Submissions Report

Triniti Stage 2 Build-to-Rent (SSD-55844212)

39 Delhi Road, North Ryde

Submitted to the Department of Planning, Housing and Infrastructure
on behalf of Stockland Development Pty Ltd

Figure 3 Comparison between the SSDA scheme and the proposed scheme

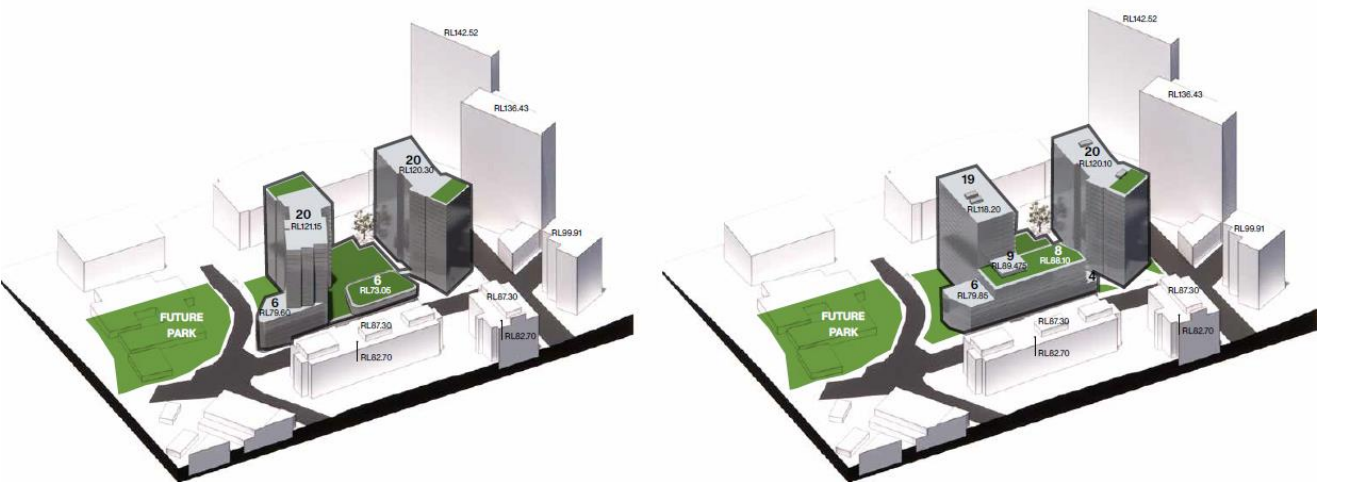
In response to the submissions raised, the built form and massing as exhibited is required to be amended to mitigate impacts to the future park. As such, the development has been amended accordingly and specifically, includes the transfer of massing from the north-eastern corner of Building C to Building B, which ultimately creates a 9 storey building for Building B and a 19 storey building for Building C.

Figure 3 below illustrates a comparison between the submitted and revised scheme that clearly shows the design amendments undertaken. The amended built form and revised distribution of massing will reduce the bulk and scale and reduce the environmental impacts to the surrounding development.

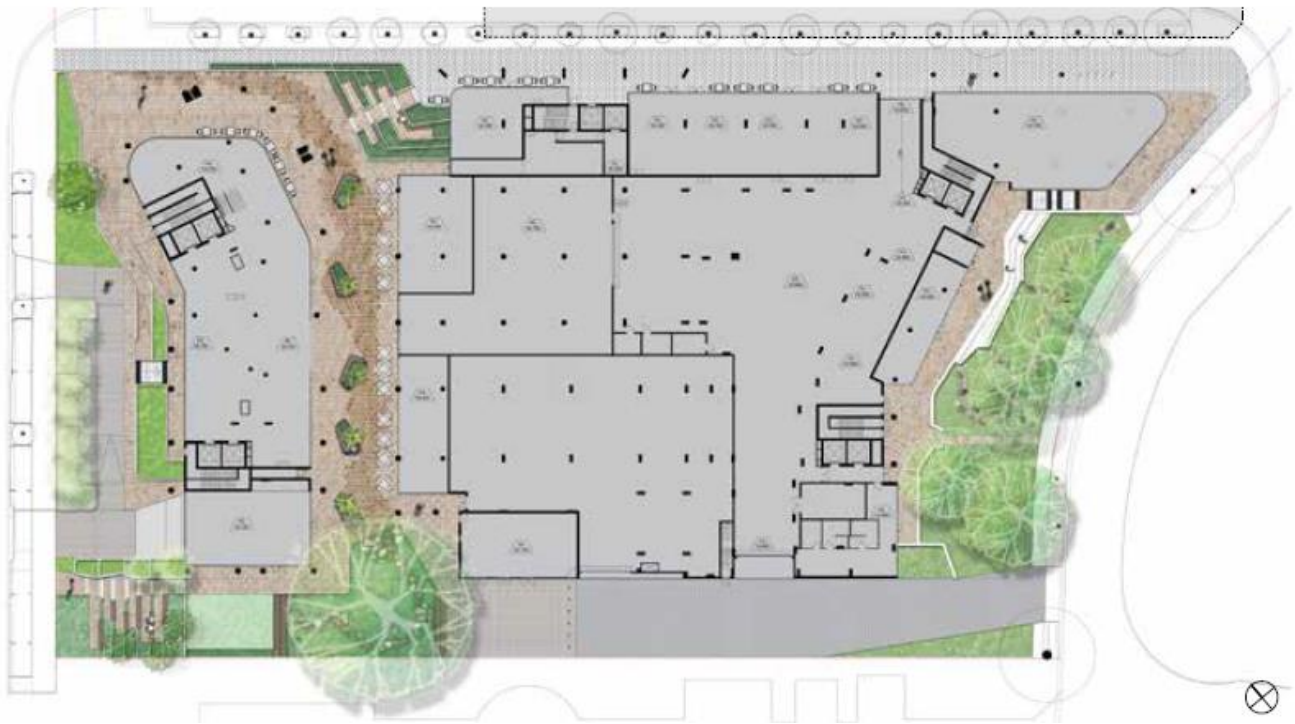
During public exhibition, the GANSW called for improved connectivity across the precinct and the configuration of the recreation areas. They also raised comments in relation to the size, permeability and openness of the entry plaza and retail lane, resulting in the public domain appearing more privatised. It was requested that the quality of the public domain be improved.

As such, the following design amendments have been made to increase the amount and improve the quality of the public domain:
